**NUCLEAR
COMMISSION**

Title: Advisory Committee on Reactor
Safeguards US EPR DCD Subcommittee
Meeting

Date: Tuesday, April 6, 2010

► Evaporator - vapor-compressor with forced recirculation

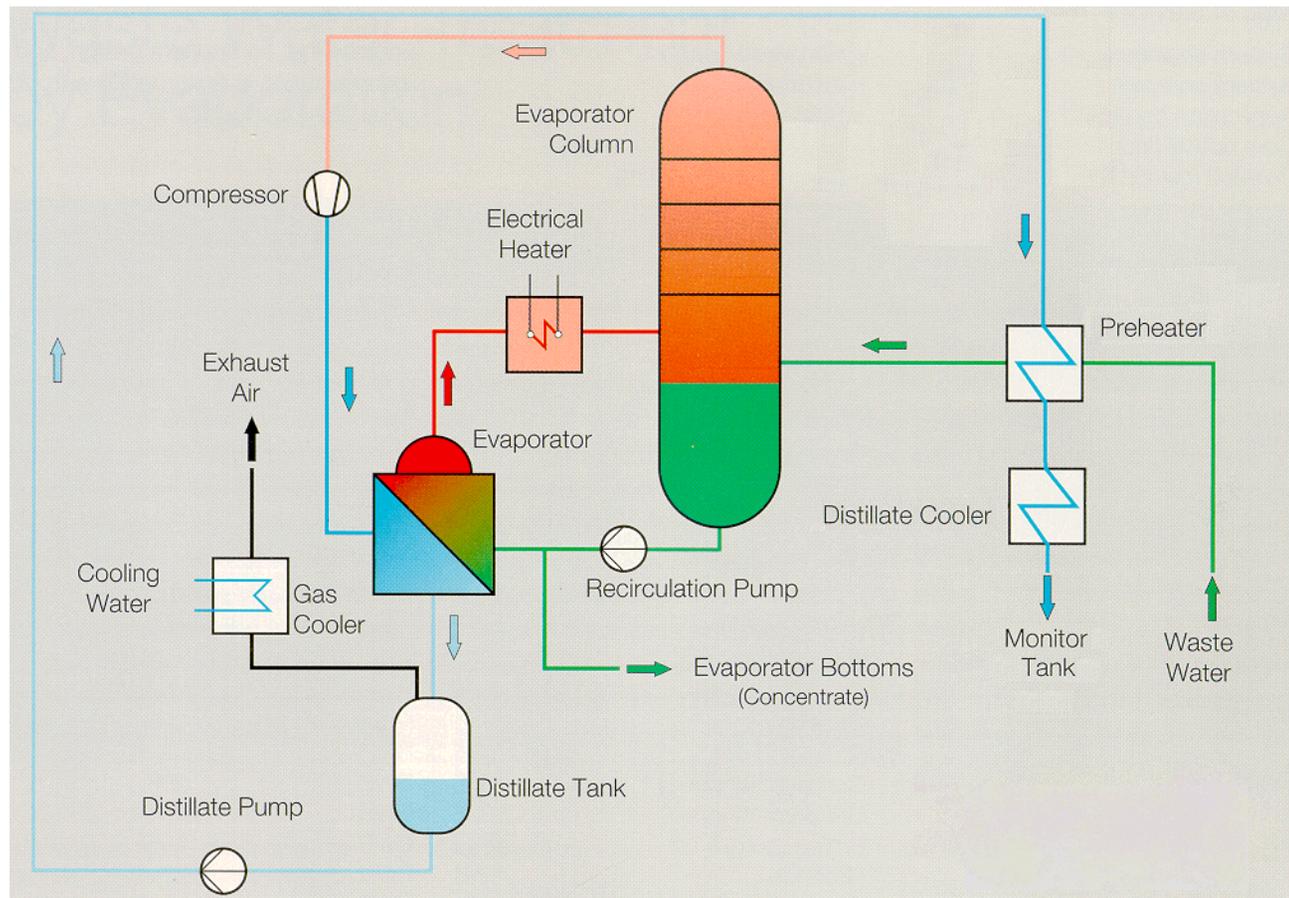
18 MEMBER BANERJEE: The only thing about
19 this that I would comment is that you've got a vapor
20 compressor which is a complicated piece of equipment,
21 and heat recovery in this system is quite a trick. So
22 I'm just wondering what drives you to these systems
23 rather than things like reverse osmosis, which are in
24 some ways much more straightforward.

► Centrifuge

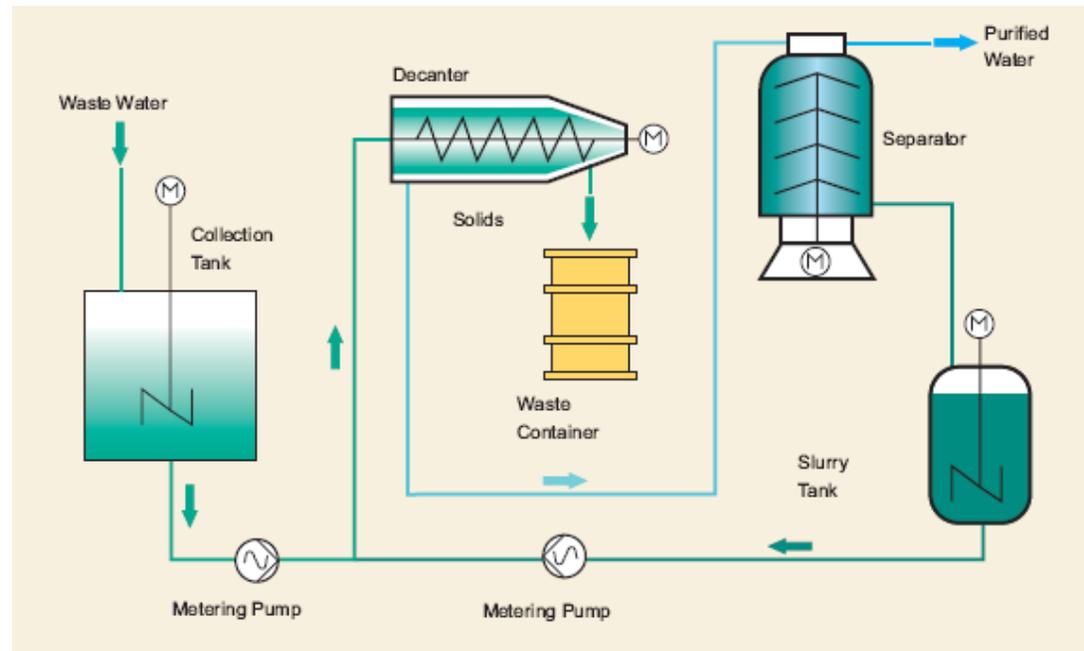
9 MEMBER STETKAR: Same question applies
10 for them, because the centrifuge is typically a fairly
11 high maintenance item. And here you start overloading
12 the evaporator.
